DESIGN REVISIONS- NOVEMBER 2019 DRB

DESIGN REVISIONS- DECEMBER 2019 DRB APPROVAL + CURRENT PROPOSED PLANS

NEW RESIDENCE
420 SOUTH HIBISCUS DR.
MIAMI BEACH, FL 33139

1 HEIGHT WAIVER/VARIANCE DIAGRAM- SOUTH ELEVATION
SCALE - 1/8" = 1'-0"

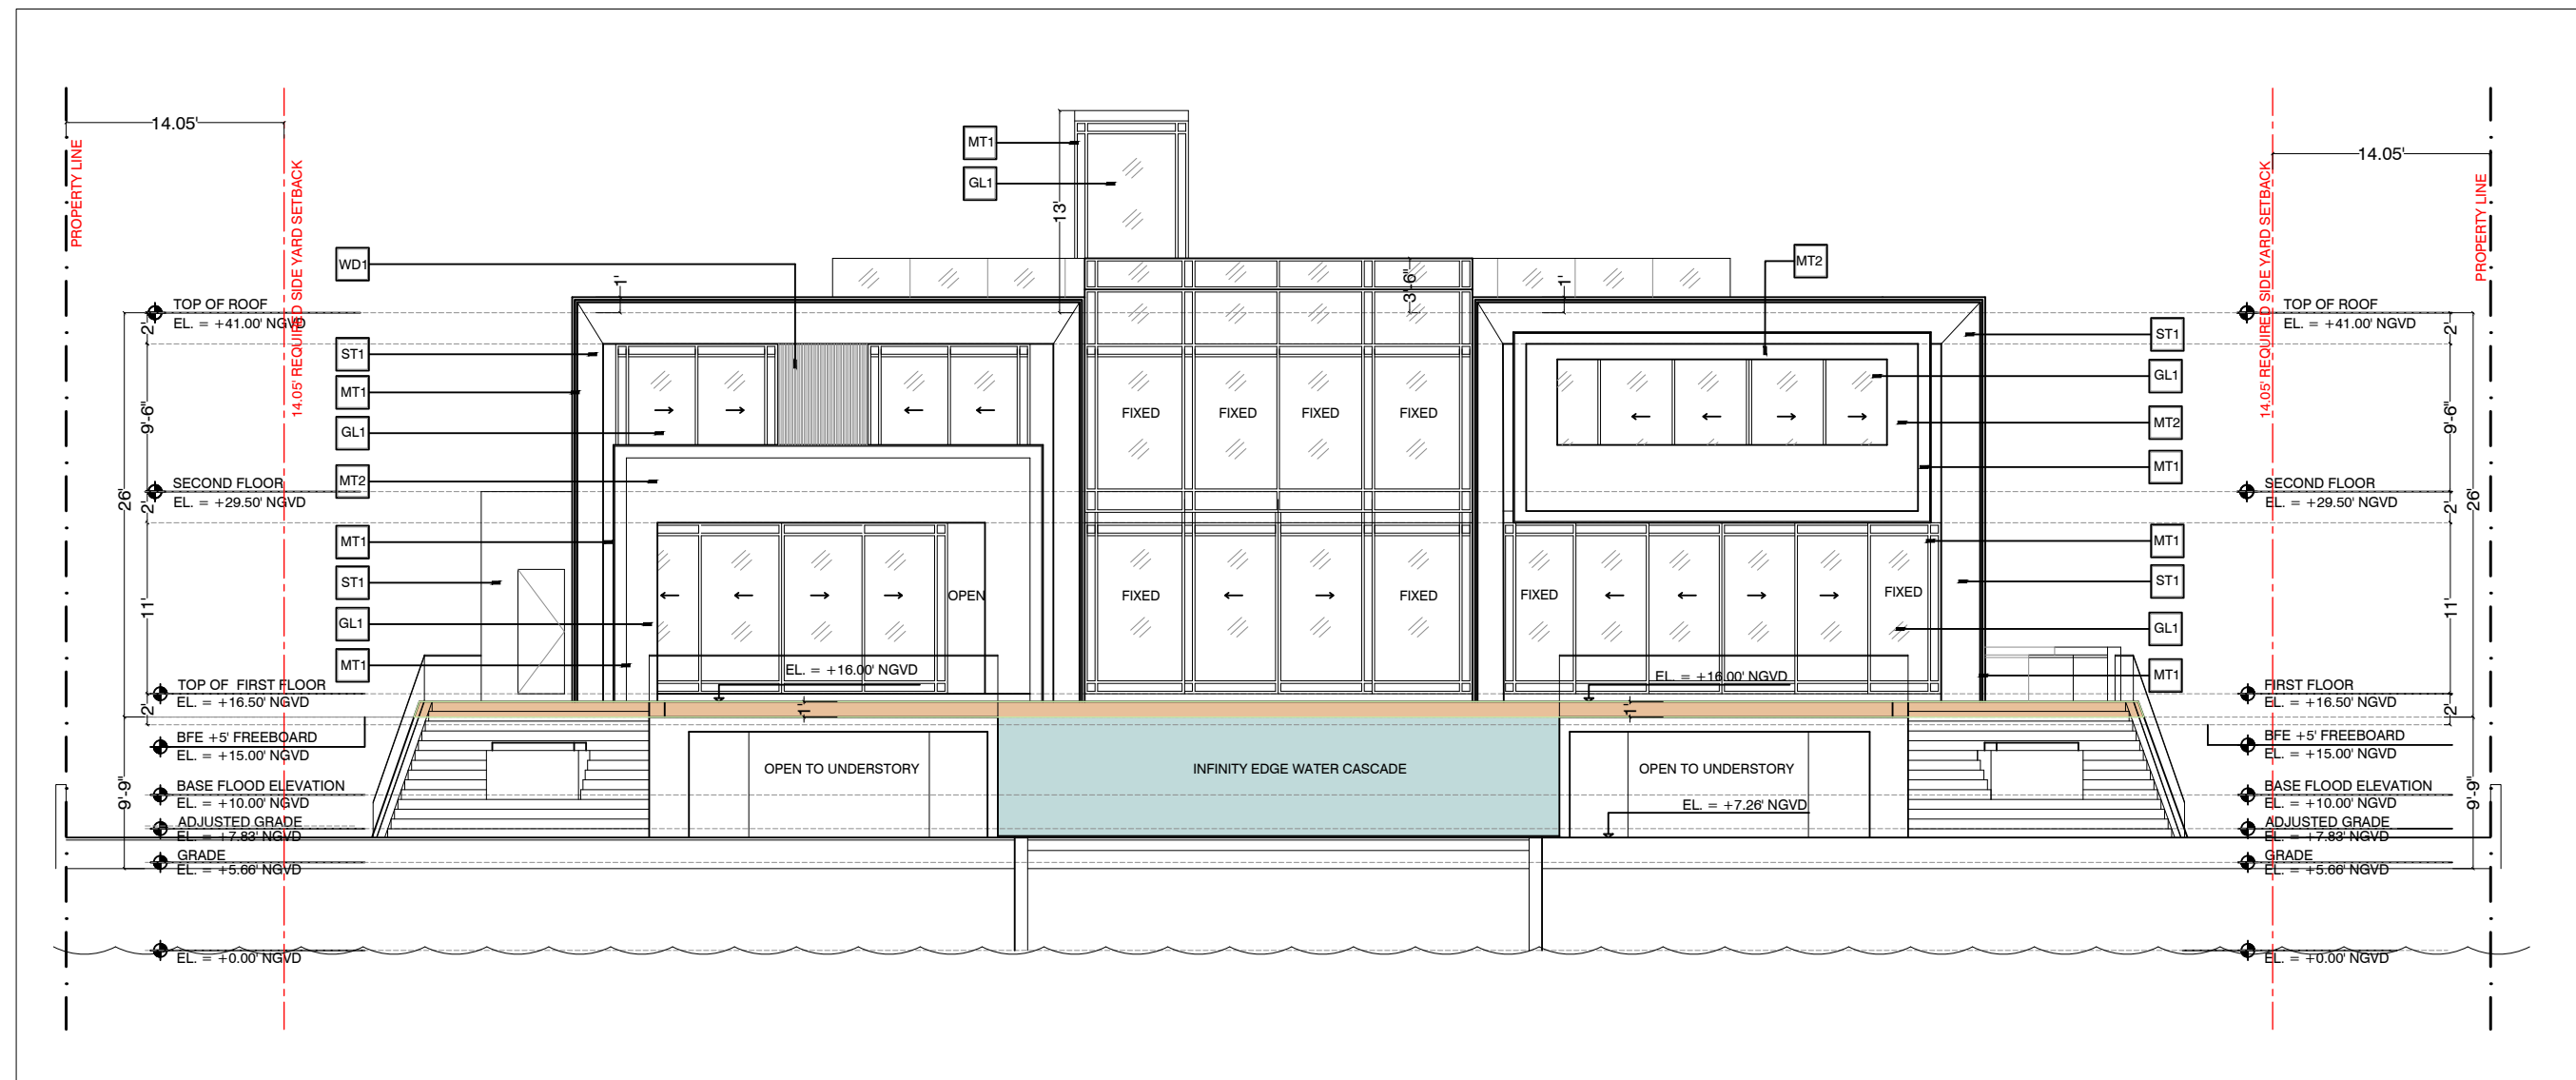
VARIANCE REQUEST: ADDITIONAL 1' OF HEIGHT FOR FOR ELEVATED POOL AND ADJACENT LAWN TERRACE WITHIN THE REQUIRED REAR YARD.

3 HEIGHT WAIVER/VARIANCE DIAGRAM- SECTION
SCALE - 1/8" = 1'-0"

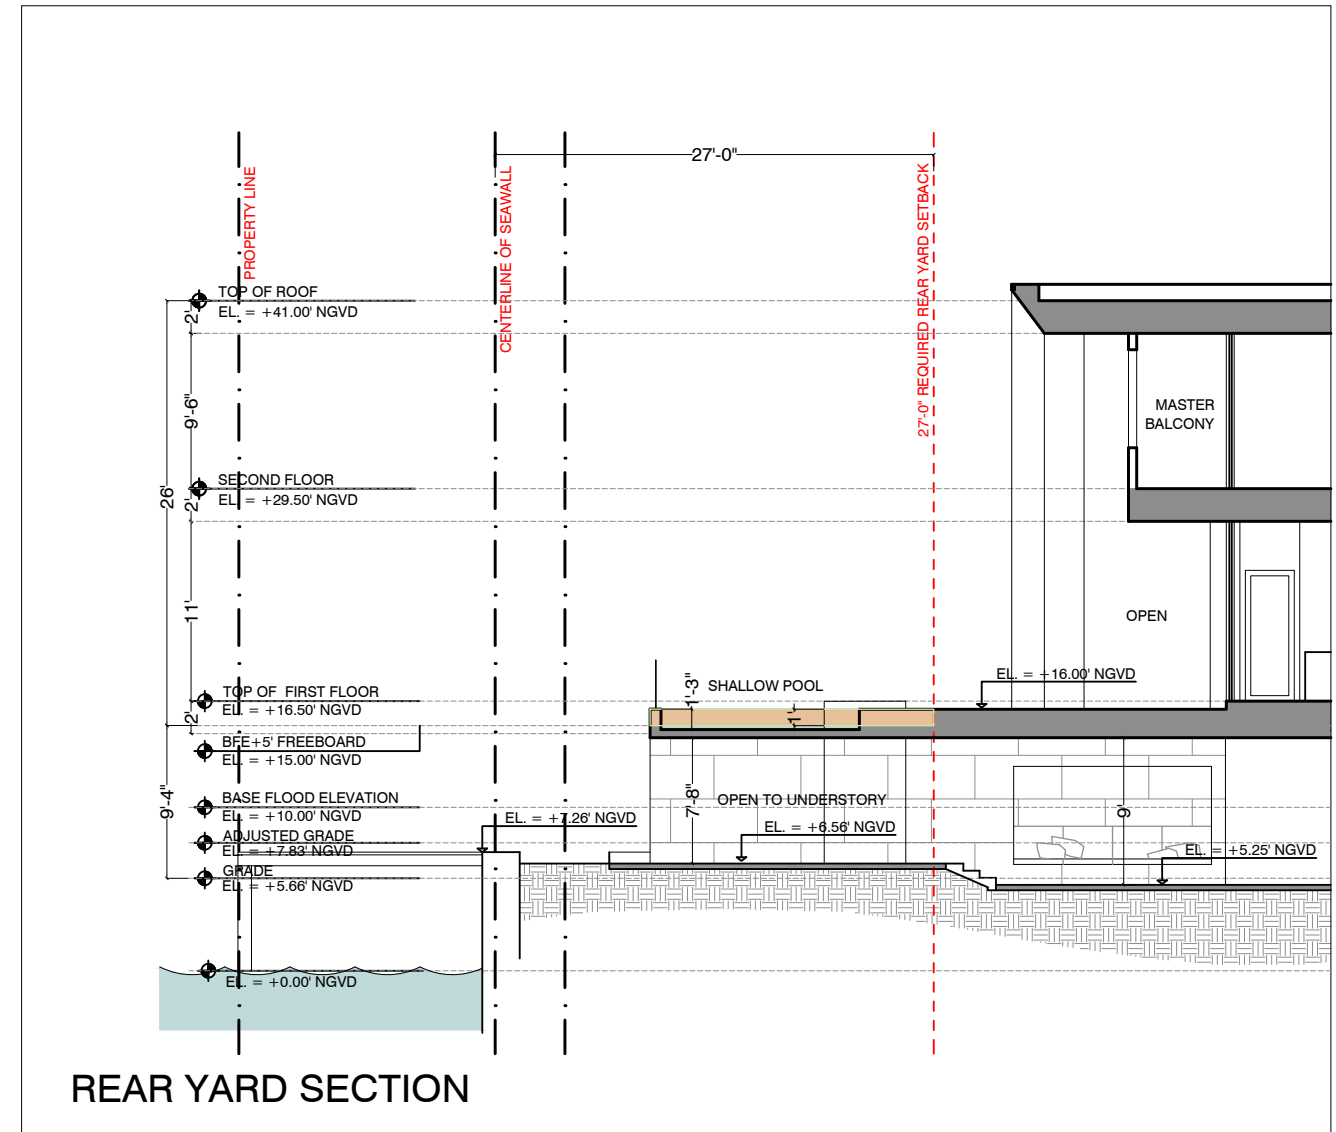
VARIANCE REQUEST: ADDITIONAL 1' OF HEIGHT FOR FOR ELEVATED POOL AND ADJACENT LAWN TERRACE WITHIN THE REQUIRED REAR YARD.
